CONSTRUCTION OF NEW MUNICIPAL SOFTBALL PARK REBID

PROJECT NO.: 08-18-C28-608

A D D E N D U M NO. 1

ADDENDUM No 1
SOFTBALL FIELD FACILITIES
MUNICIPAL PARK
McALLEN, TEXAS

Project No.:	33348
Issued:	07-11-18
Drawn By:	E.M.
Checked By:	H.A.
Scale:	AS NOTED
Sheet Title	PLUMBING PARTIAL SITE PLAN AND SANITARY SEWER PLAN
P1.01	Sheet Number

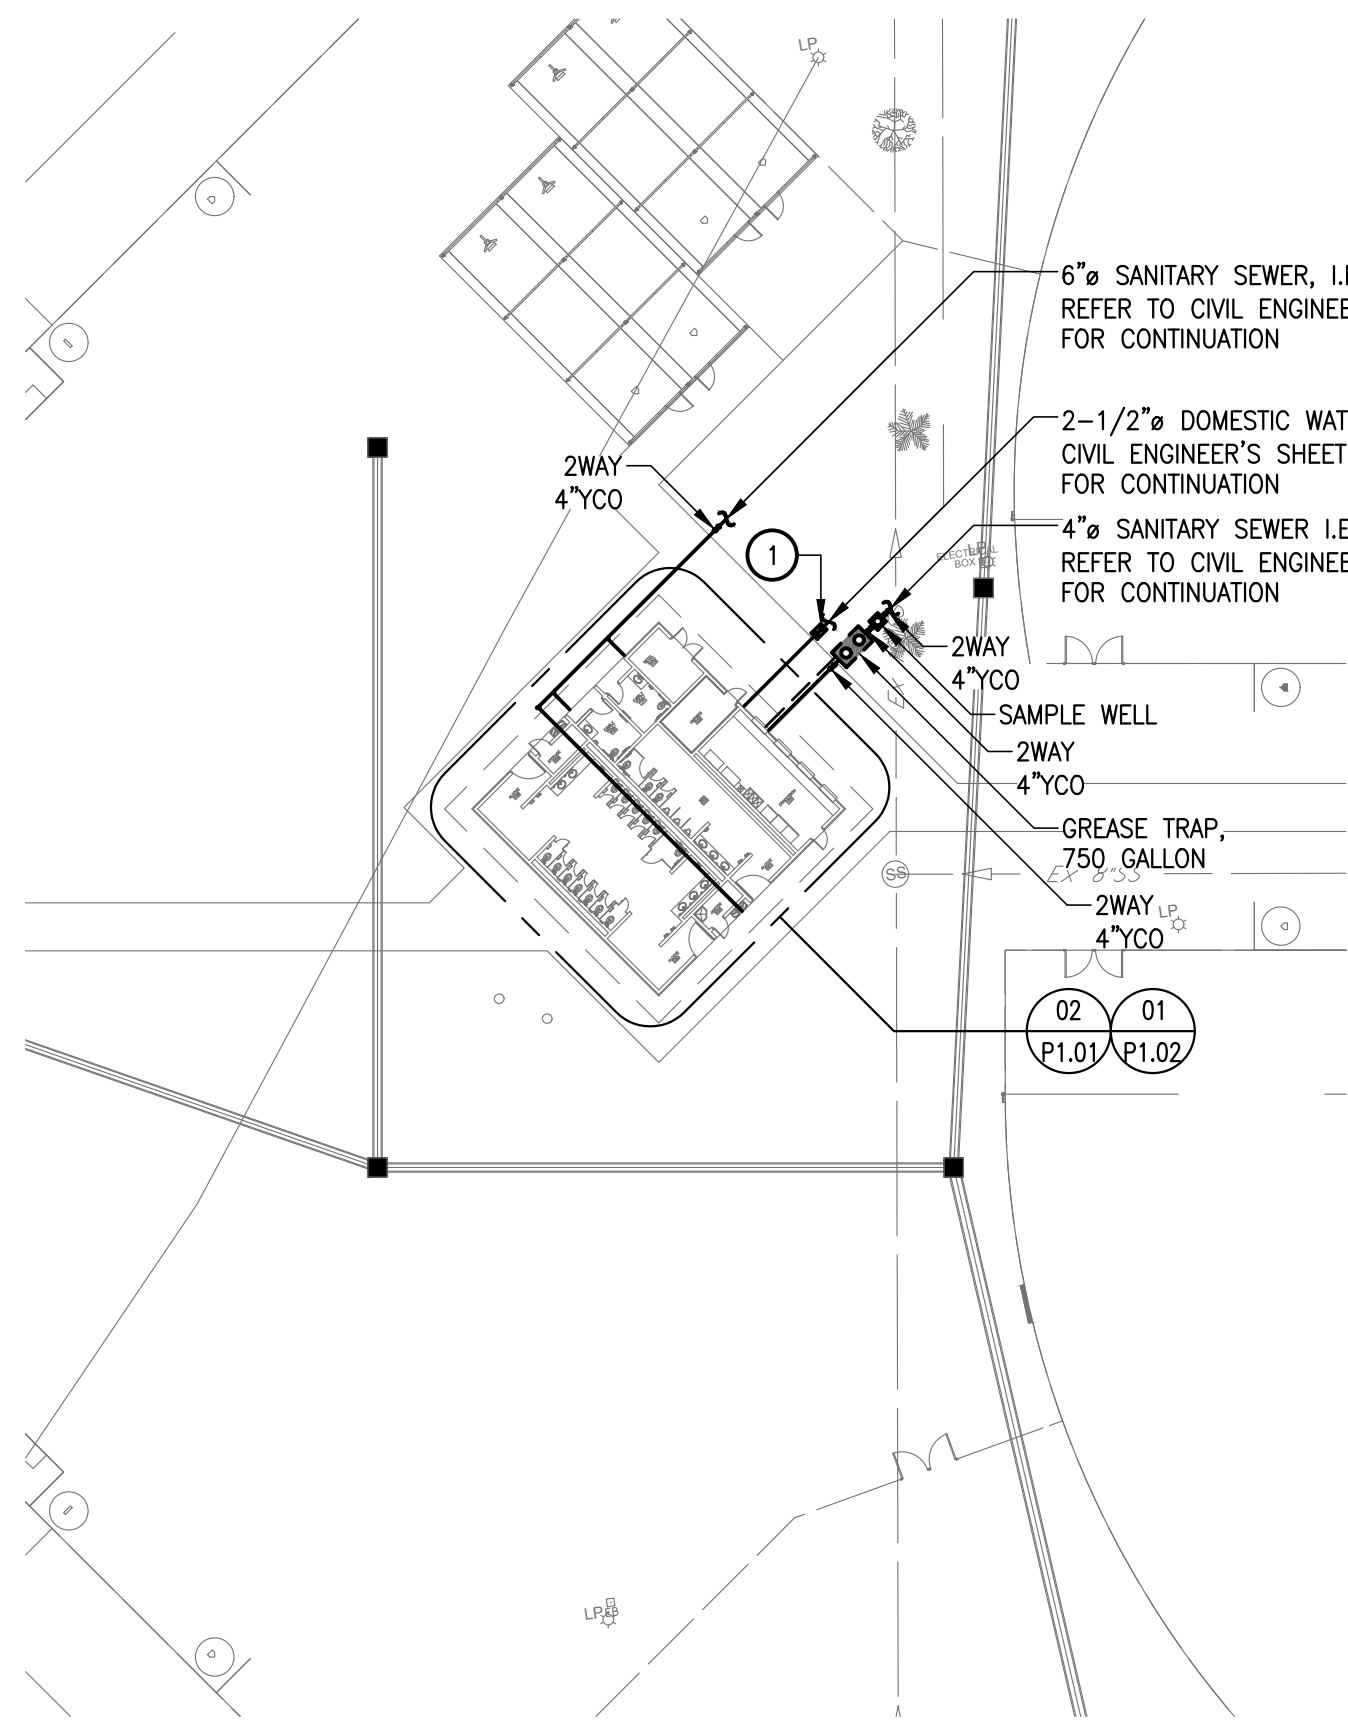
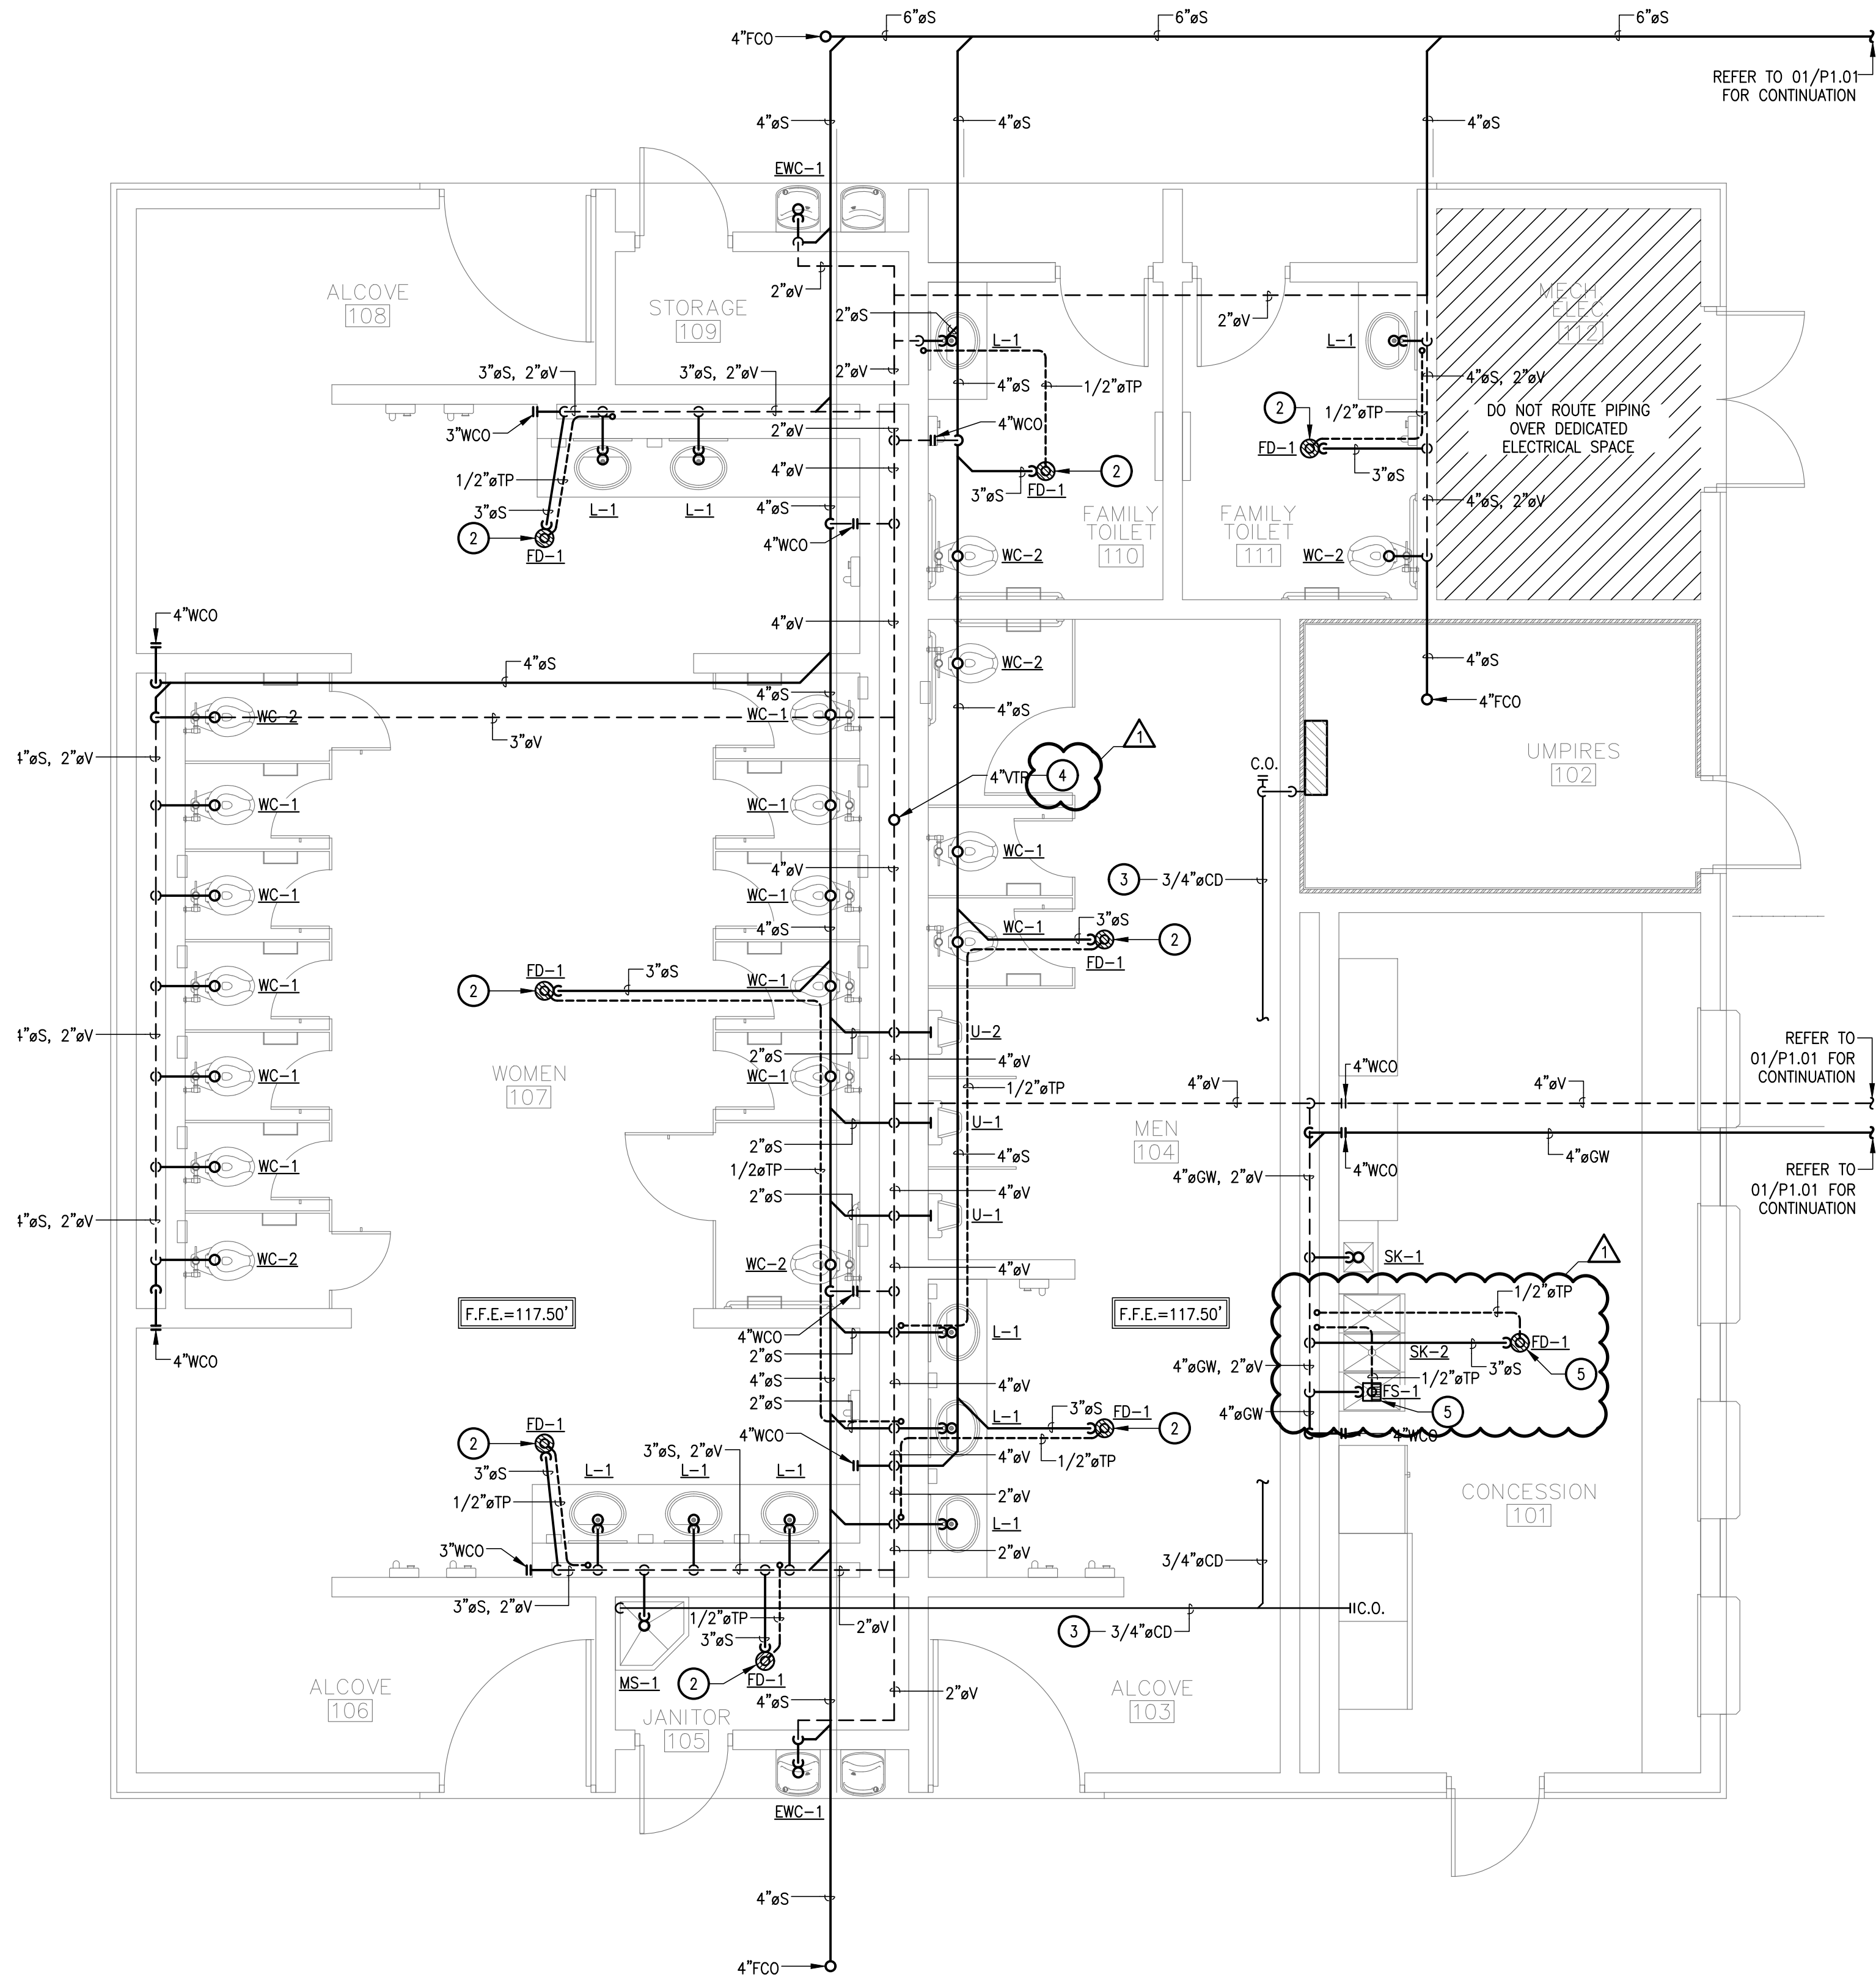
- ITEM 1. Modification: Sheet P1.01, added Keyed Note 4. Keynote to terminate VTR inside cupola addition.
- ITEM 2. Modification: Sheet P1.01, added Keyed Note 5. Keynote to incorporate trap primer lines under slab.
- ITEM 3. Modification: Sheet P1.02, added trap primer valve above ceiling.

Project No.:	33348.001
Issued:	07/11/2018
Drawn By:	CE
Checked By:	TM
Scale:	AS SHOWN
Sheet Title	SITE PLAN
L3.02	Sheet Number

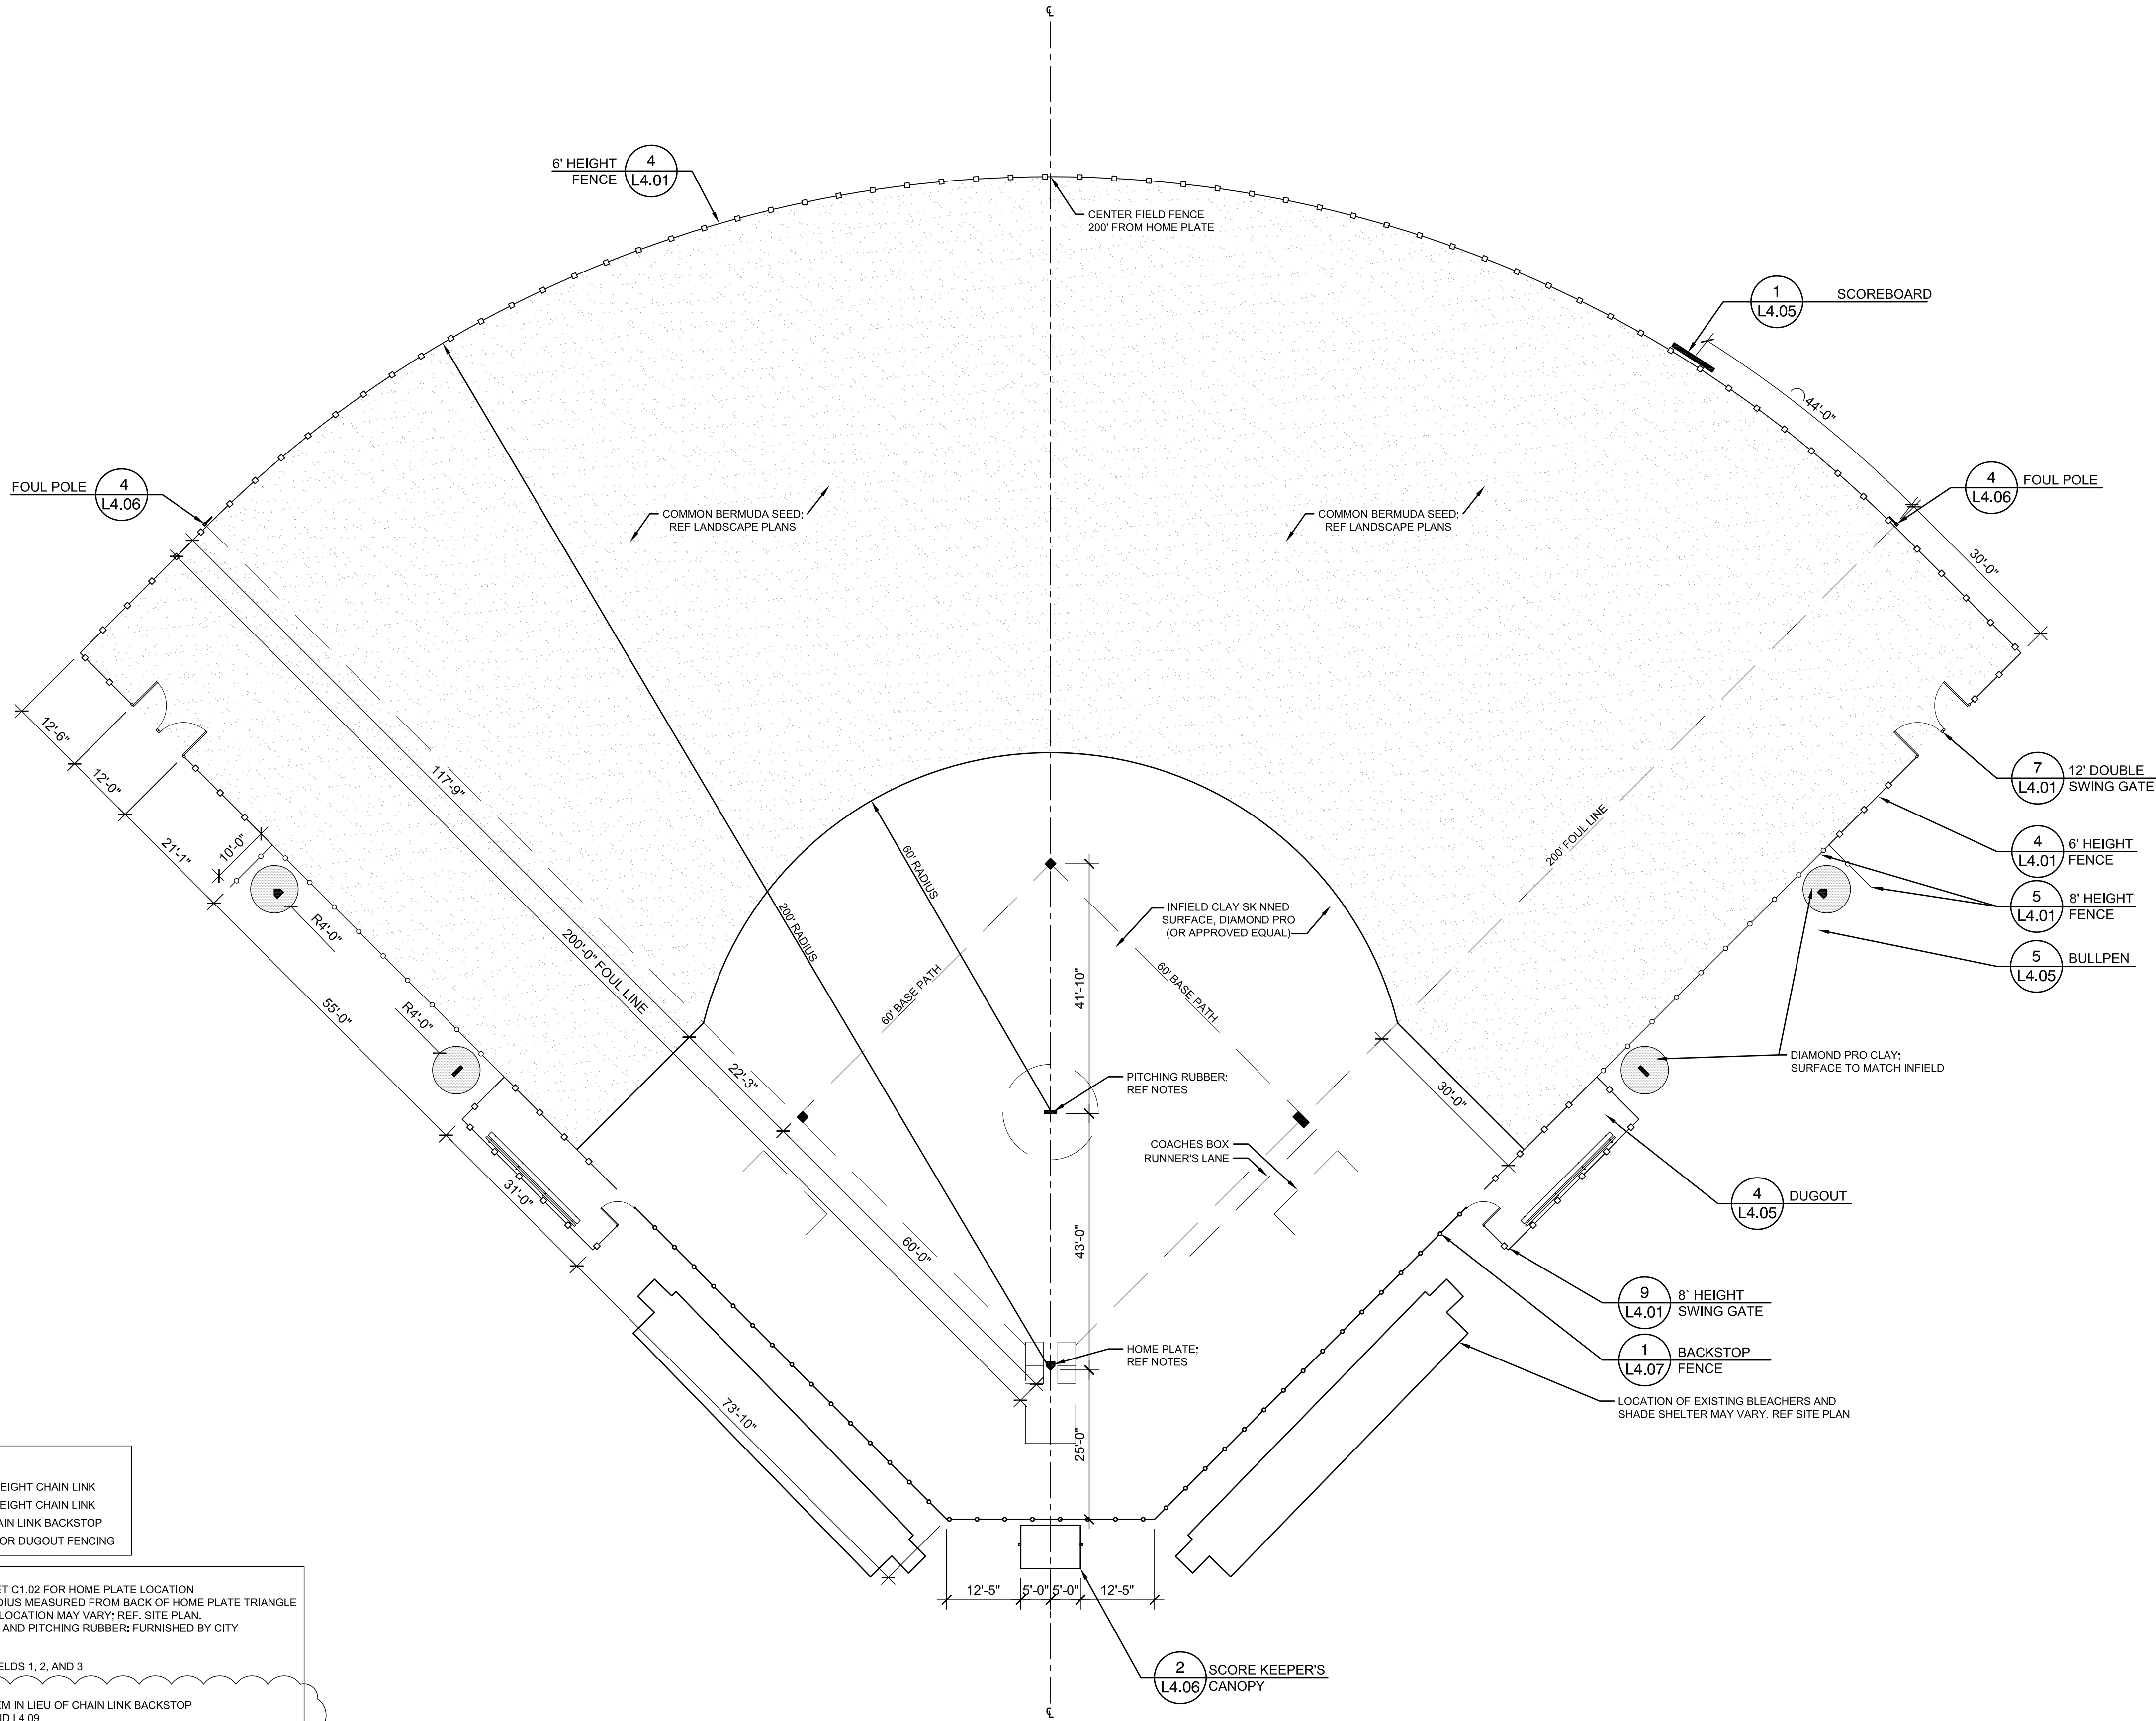
- L2.02 Modified sidewalk and dimensions leading to playground area.
- L3.02 Modified sidewalk leading to playground area.
- L4.03 Added note to indicate Net Backstop as Alternate No. 5.
- L4.04 Added note to indicate Net Backstop as Alternate No. 5.
- L4.07 Revised Details 1 and 2 to indicate chain link fabric to be 9 gauge steel .
- L4.08 NEW SHEET. Added sheet to include details for net backstop.
- L4.09 NEW SHEET. Added sheet to include detail for net backstop.
- L5.00 Revised Overall Plant Schedule to indicate new Grass Hydromulch quantity due to sidewalk modification.
- L5.02 Modified sidewalk leading to playground area. Revised Plant Schedule to indicate new Grass Hydromulch quantity due to sidewalk modification.
